AMENDMENTS TO THE DRAWINGS:

REMARKS/ARGUMENT

Fig. 12a

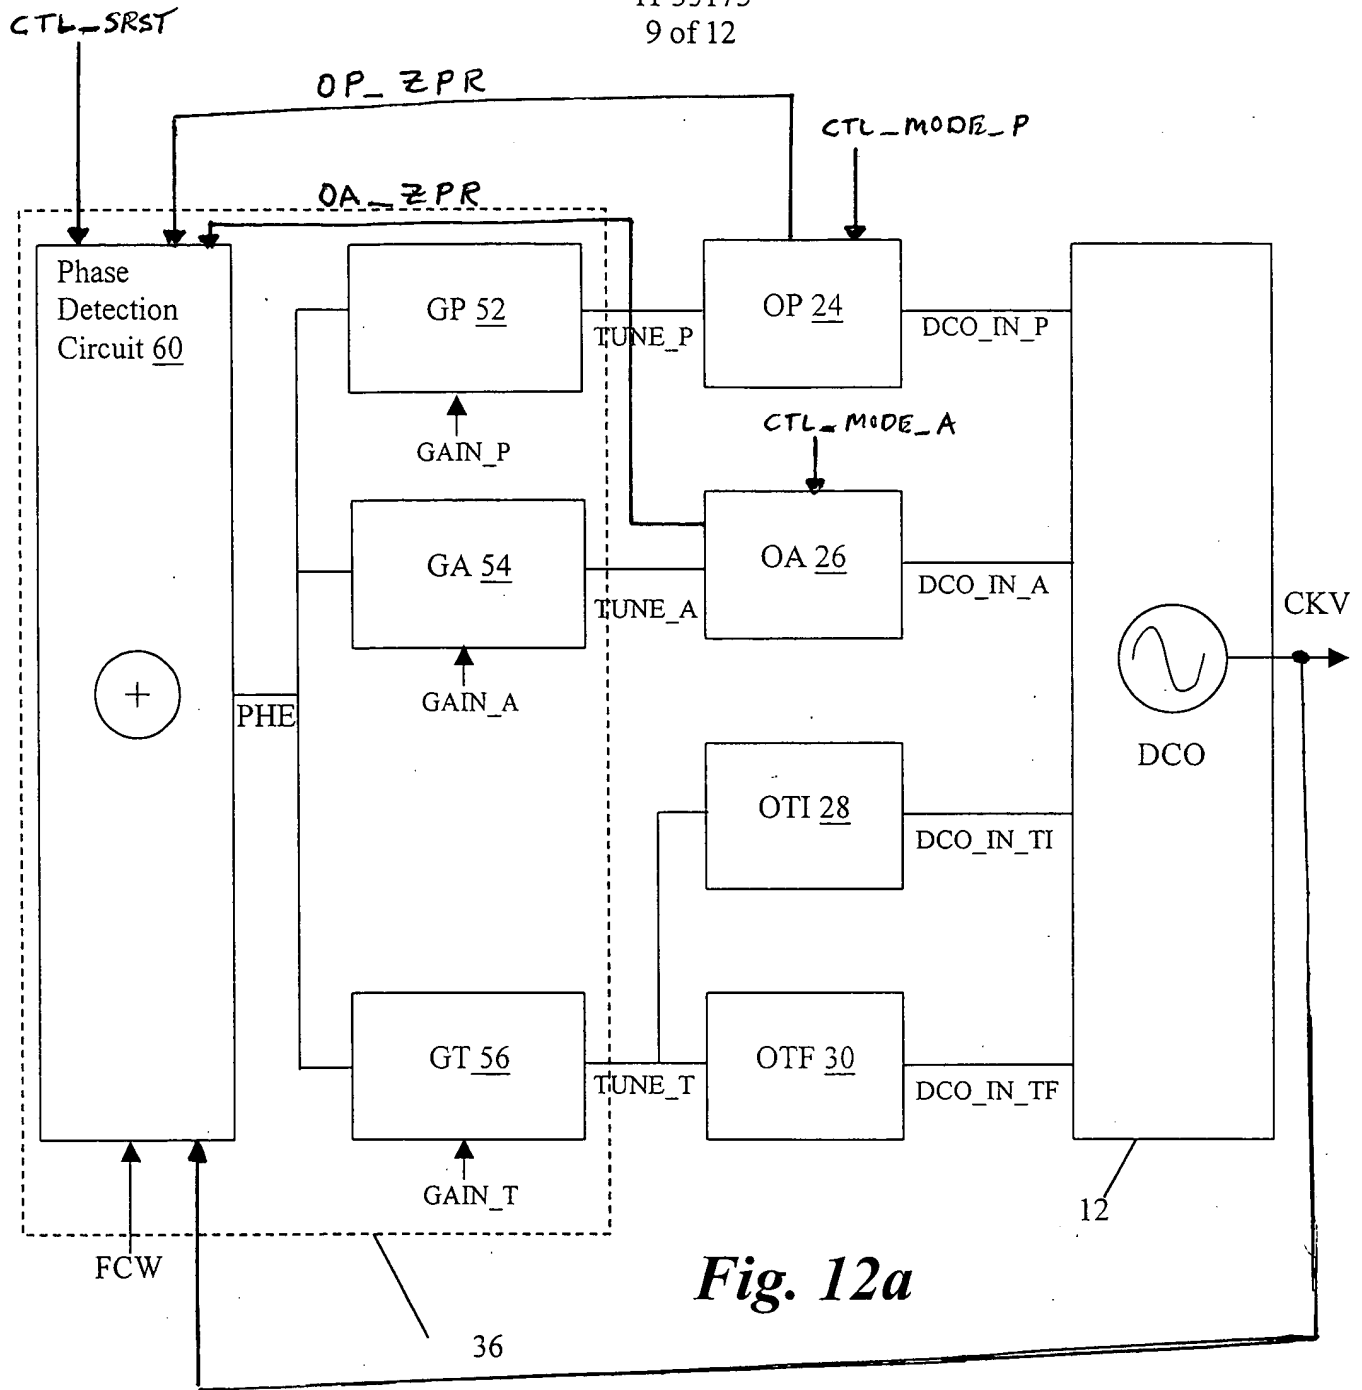
Applicants propose amending Figure 12a to clarify the invention. Applicants propose:

1) adding a signal line from the output of DCO 12, which outputs clock signal CKV, to an input of Phase Detection Circuit 60. Support for this amendment is found in paragraph [0033] and Figure 1 & 12b.

2) adding a signal line, coupled to receive a signal CTL_SRST, to an input of Phase Detection Circuit 60. Support for this amendment is found in paragraph [0056] and Figures 13 & 14 which show synchronous reset CTL_SRST.

3) adding a signal line, enabled to carry a mode switch signal OA_ZPR, from an output of control circuit 26 to an input of Phase Detection Circuit 60. Support for this amendment is found in paragraphs [0066-0067] and Figures 13 and 14.

4) adding a signal line, enabled to carry a signal OP_ZPR, from an output of control circuit 24 to an input of Phase Detection Circuit 60. Support for this amendment is found in paragraphs [0065 & 0067] and Figures 13 and 14.

5) adding a signal line, coupled to receive a signal CTL_MODE_P, to an input of control circuit 24. Support for this amendment is found in paragraphs [0064-0065] and Figure 13.

6) adding a signal line, coupled to receive a signal CTL_MODE_A, to an input of control circuit 26. Support for this amendment is derived from Figure 13 which shows CTL_MODE_P for the PVT oscillator controller or interface 24. This equivalency is established in [0066]. The acquisition controller 26, as described in [0068], is significantly identical to the controller 24, and has an equivalent mode switch signal. Accordingly, Figure 12a has been amended to show the CTL_MODE_P and CTL_MODE_A signals entering OP 24 and OP 26 circuits, respectively.

Figure 12a has been amended to add mode switch signals OP_ZPR and OA_ZPR which enter the phase detection circuit 60 from the OP 24 and OA 26 circuits, respectively, to better illustrate the invention.

Applicants further propose amending Figure 12a to clarify the invention. Figure 12a shows more details and more actual interconnects between the digitally-controlled oscillator 12, plurality of control circuits 24-30, and the phase detection circuit 60 than does Figure 1. While a “mode switch signal” is not shown in Figures 1 or 12a, it is shown in Figure 13 as CTL_MODE_P for the PVT oscillator controller or interface 24. This equivalency is established in [0066]. The acquisition controller 26, as described in [0068], is significantly identical to the controller 24, and has an equivalent mode switch signal. Figure 12a has been amended to show the CTL_MODE_P and CTL_MODE_A signals entering OP 24 and OP 26 circuits, respectively. No new matter has been added. Applicants respectfully request approval.
